B&A, on behalf of Minto Communities, is pleased to re-submit the Outline Plan and Land Use Redesignation application in response to the second Detailed Review for LOC2023-0359.

2501 Richmond DR2		
Prior to Calgary Planning Commission		
Planning		
No.	City Comment (Abridged)	Response
1	Submit a complete digital set of the amended plans in PDF format and a separate PDF response letter that provides a point-by-point explanation as to how each of the Prior to Calgary Planning Commission conditions were addressed and/or resolved. The submitted plans must comprehensively address the Prior to Calgary Planning Commission conditions as specified in the DR document. Ensure that all plans affected by the revisions are amended accordingly. To arrange the digital submission, please contact the File Manager directly.	Thank you for this detailed review of a significant application. Both updated drawings and line-by-line responses are attached and provided below.
2	If the scope of the proposed application changes, please provide an updated one-page applicant's submission letter to send to neighbours and to include in the report to Calgary Planning Commission and Council. The submission letter sho

drawing
 Landscape Plan

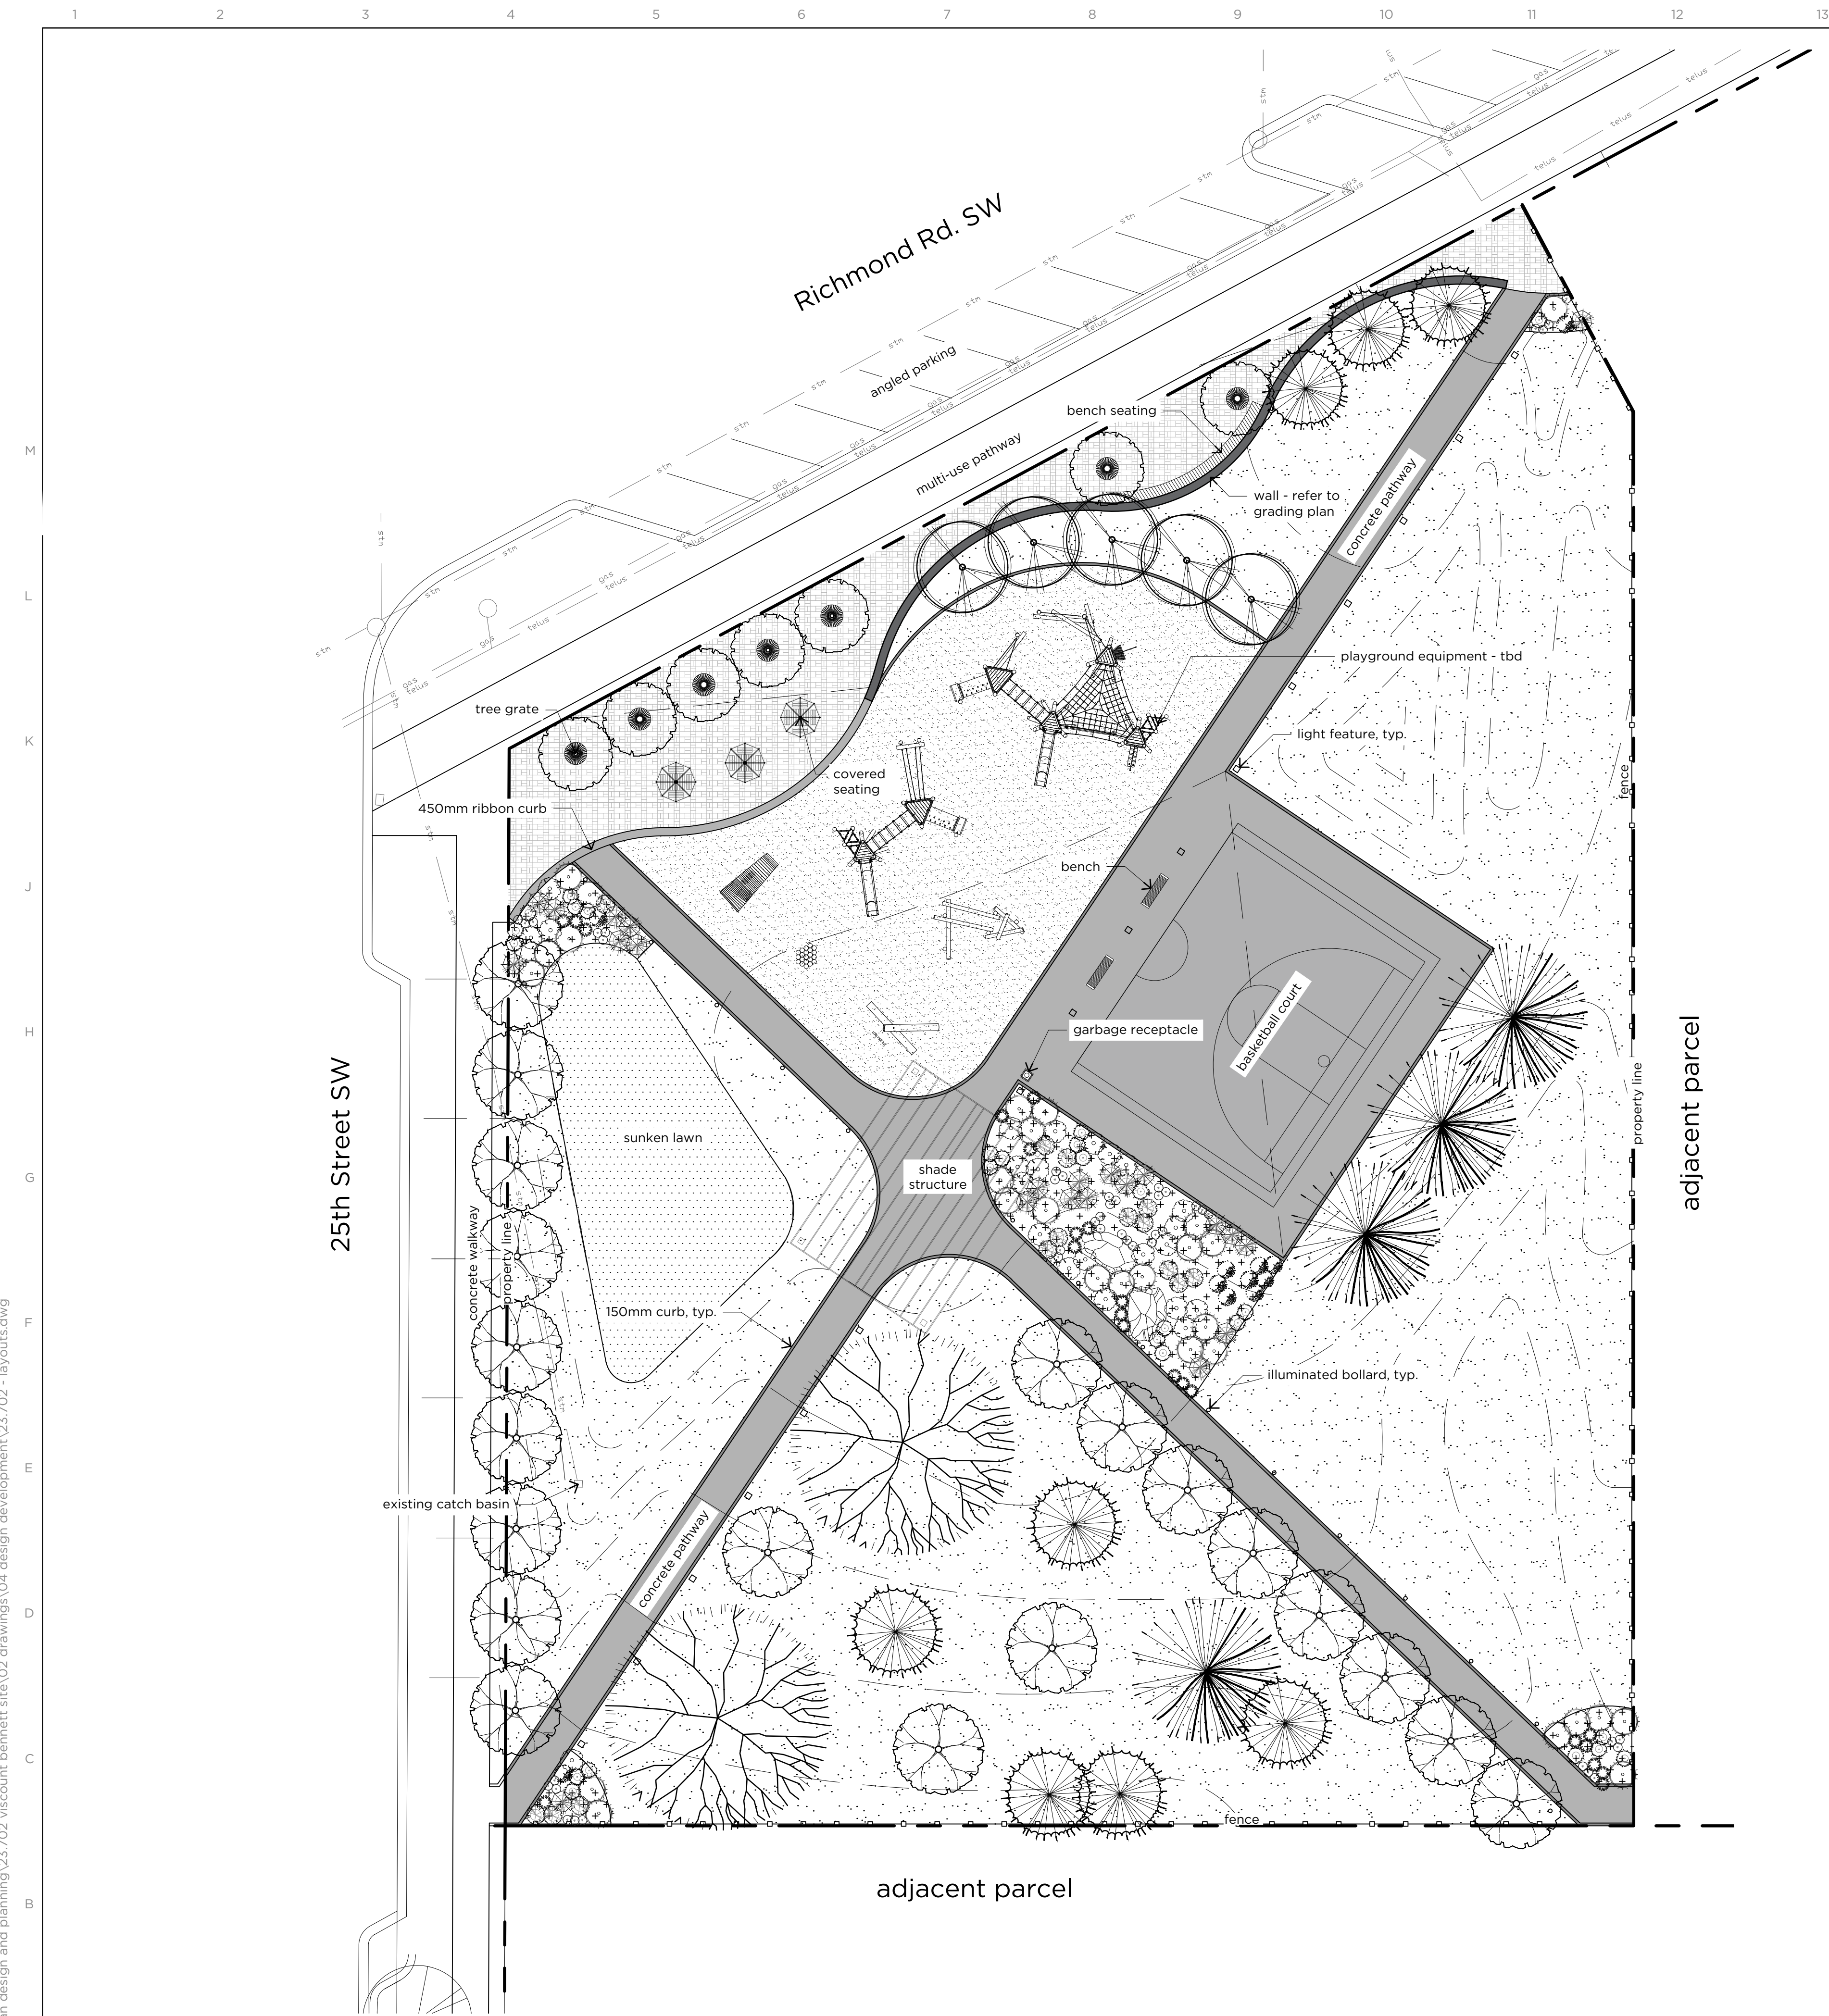
An updated Pedestrian Network Plan has also been submitted.
6	The proposed location and dimensions of the proposed MR (Municipal Reserve) addresses prior comments. Provide further detail in the form of a Landscape Concept Plan.	<p>We are excited to pursue detailed design of this new community space, bringing it one step closer to fruition.</p> <p>Parcel lines throughout site were refined to further reduce grade changes within the proposed MR and maximize usable space.</p> <p>A Landscape Concept Plan has been submitted.</p>
7	Revise proposed road cross-sections (five specific amendments requested).	The requested amendments have been made and included in the updated Outline Plan.
Utility Engineering		
8	An updated Sanitary Servicing Study to align with the revised resubmission is currently under review.	Our team will await further City feedback on proposed sanitary services. Our engineers have noted that sufficient downstream capacity exists to support the proposed development. Findings and proposed connections are available in materials from November 2023 and July 2024 submissions, available at https://2501richmond.com .

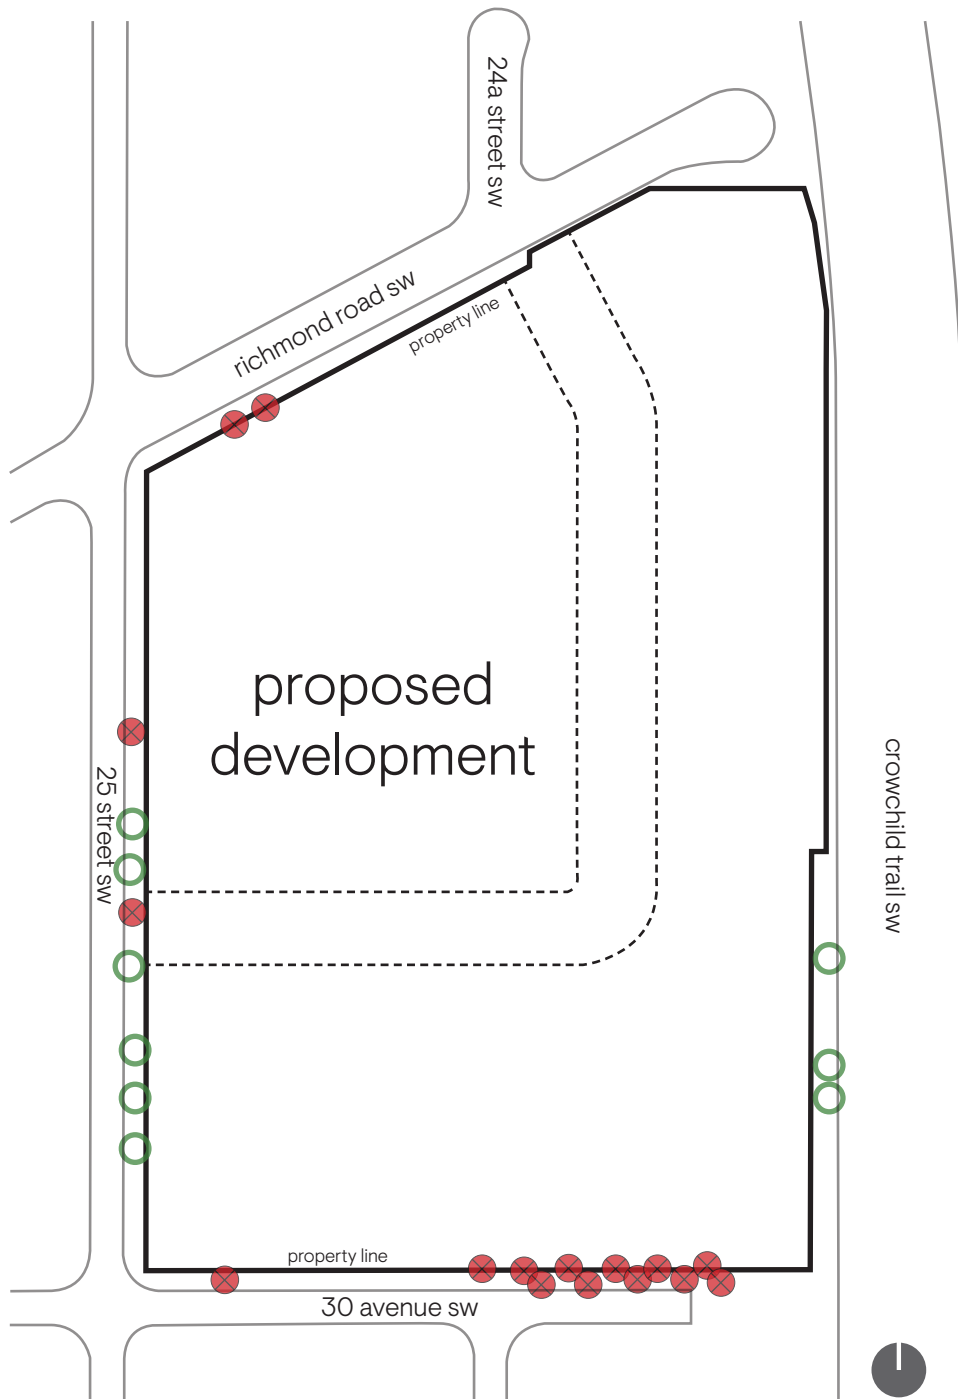
5	Revise the Land Use and Outline Plan to address tree management and integration of proposed pedestrian links to existing infrastructure.	An updated map of public trees has been submitted. Private trees will be considered at Development Permit stage based on interface with utilities, right of ways, grading, and other site influences. Safe decommissioning of the existing building may also necessitate removal of some trees. A significant net increase in tree canopy on the site is expected over the life of this development.
